Euro Knitwear Limited

23rd August, 2016

Observations

Flat slab vulnerable to punching shear

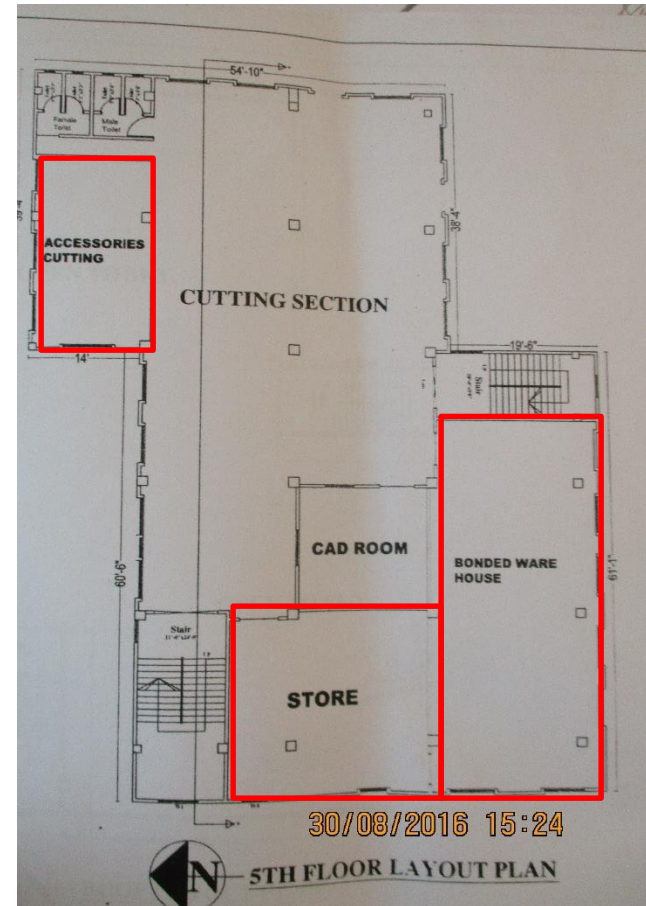
Internal columns have large tributary area but small slab thickness. Loading limit of 42 psf should be maintained until further investigation.

Item No.	Observation	Recommended Action Plan	Recommended Timeline
1	Flat slab vulnerable to punching shear	Reduce loading to 2 kPa (42psf) on all span of all floors pending the outcome of assessment.	Immediate - Now
2	Flat slab vulnerable to punching shear	Factory Engineer to review the safe load limit and carry out punching shear checks. Allowable floor loading plans to be prepared to establish where storage loads may be placed.	6-weeks
3	Flat slab vulnerable to punching shear	Implement remedial measures which will be the outcome of assessment	6-months
4	Flat slab vulnerable to punching shear	Regular inspection of load management	6-months
5	Localized areas of high loading	Reduce loading to 2 kPa (42psf) on all span of all floors pending the outcome of assessment.	Immediate - Now
6	Localized areas of high loading	Produce and actively manage a loading plan for all floor plates within the factory giving consideration to floor capacity and column capacity.	6-weeks

Localized areas of High Loading

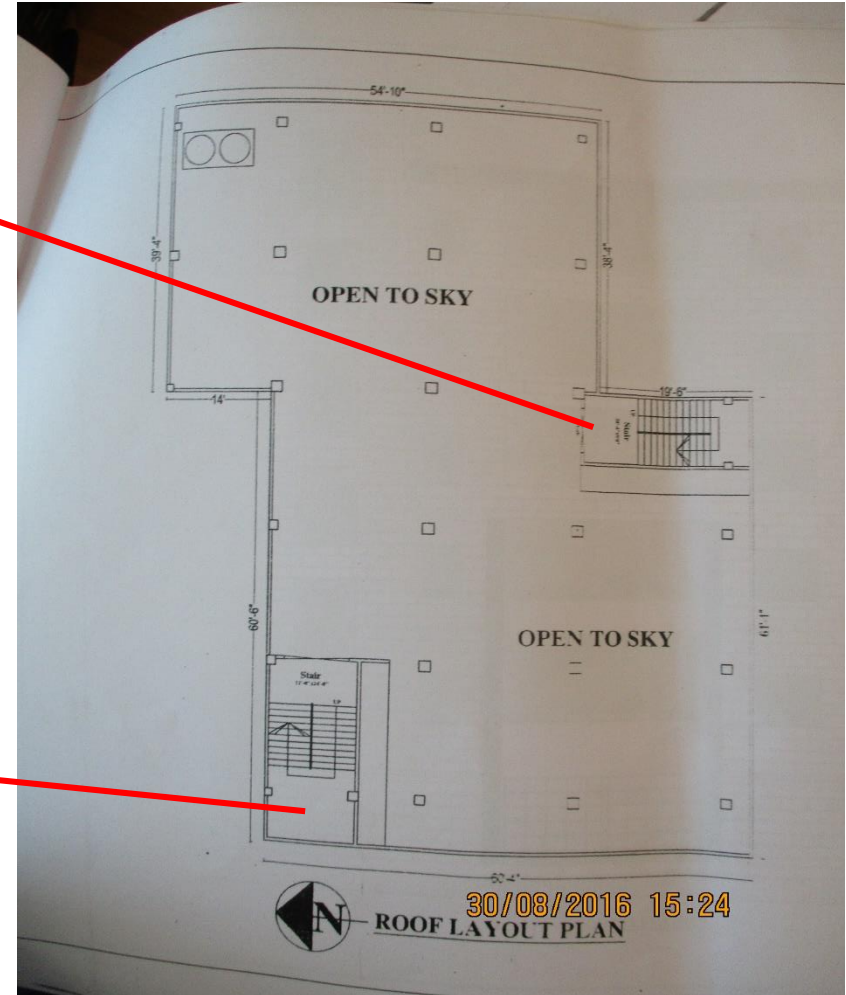
We observed loading was more than 42 psf on storage areas at 5th floor . No load management system was visible.

2 plastic water tanks were found on the staircase slab (not shown in the drawings). Factory engineer to verify that the slabs are adequate to carry these point loads.

7	Localized areas of high loading	Post load plans on all floors	6-weeks
8	Localized areas of high loading	Provide load markings on all storage areas	6-weeks
9	Localized areas of high loading	Continue to implement load plan.	6-months

Toilet build up (all floors)

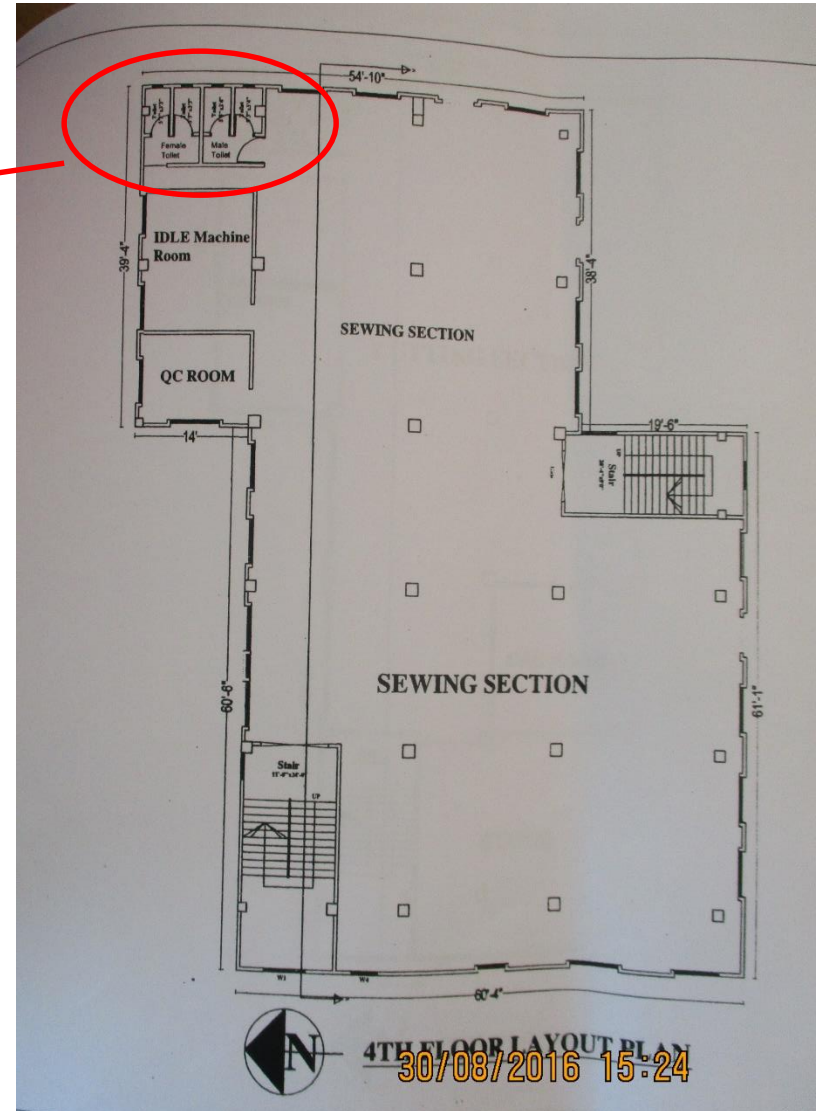
12cm high floor build-up in toilet area supported by concrete slab.
Building Engineer to check that the slab has been adequately designed to carry floor build-up loads

Limit density of loading in cantilever areas

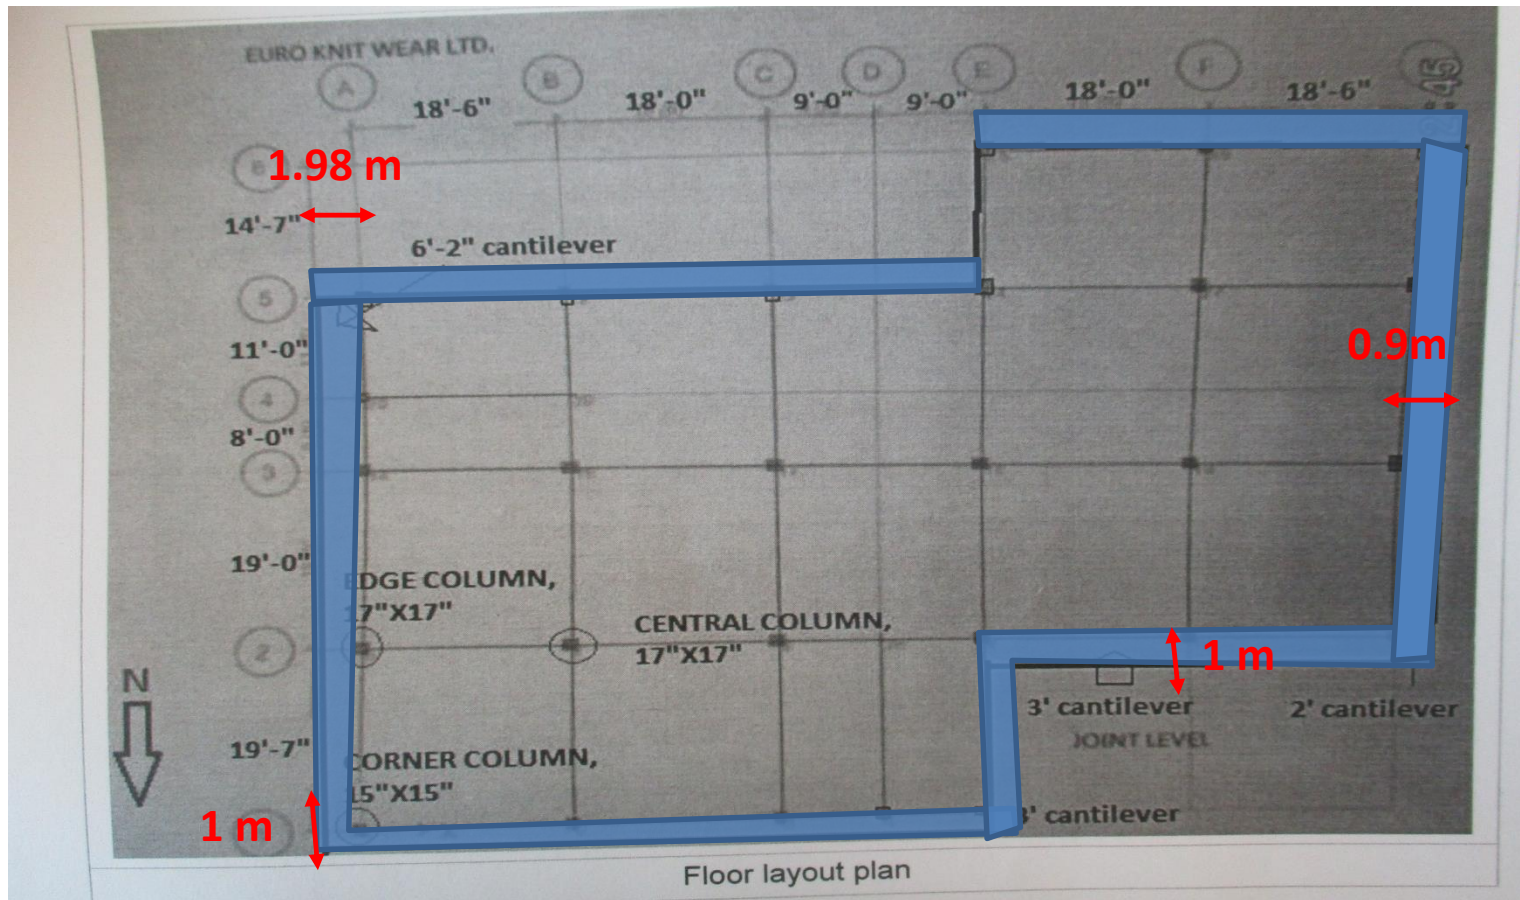
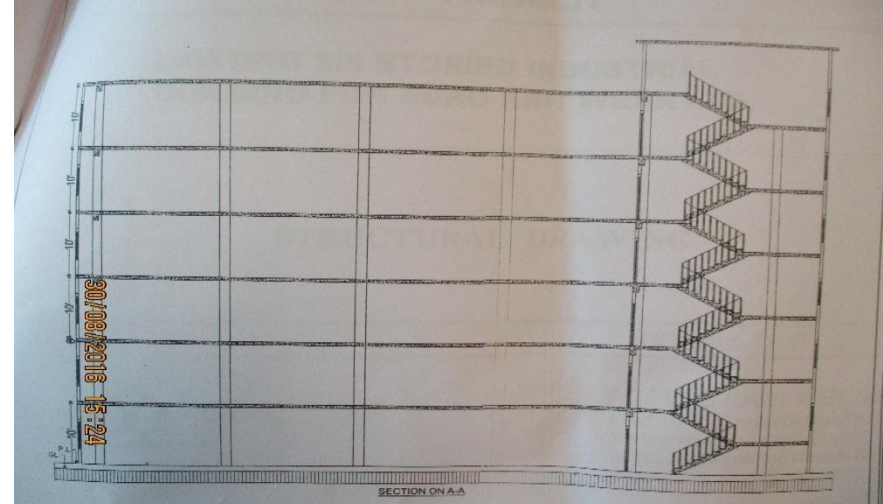
Cantilever portions were located along the perimeter of the building.

Storage was observed in cantilever portions. Cursory calculations indicate these regions are prone to excessive deflection. Loading limit of 1 kPa should be until further assessment.

Item No.	Observation	Recommended Action Plan	Recommended Timeline
10	Limit density of loading in cantilever areas	Limit loading on cantilever portions to 1 kPa (21 psf) pending the outcome of assessment.	Immediate - Now
11	Limit density of loading in cantilever areas	Factory engineer to assess the capacity of cantilever slabs and check whether the deflection is within the limit.	6-weeks
12	Limit density of loading in cantilever areas	Produce and actively manage a loading plan for all cantilever areas.	6-weeks
13	Limit density of loading in cantilever areas	Carry out remedial works suggested in the assessment report.	6-months
14	Limit density of loading in cantilever areas	Continue to implement load plan.	6-months
15	Lateral stability system to be verified	Factory Engineer to check the overall structural system under lateral loads to verify structural safety as part of the assessment report.	6-weeks
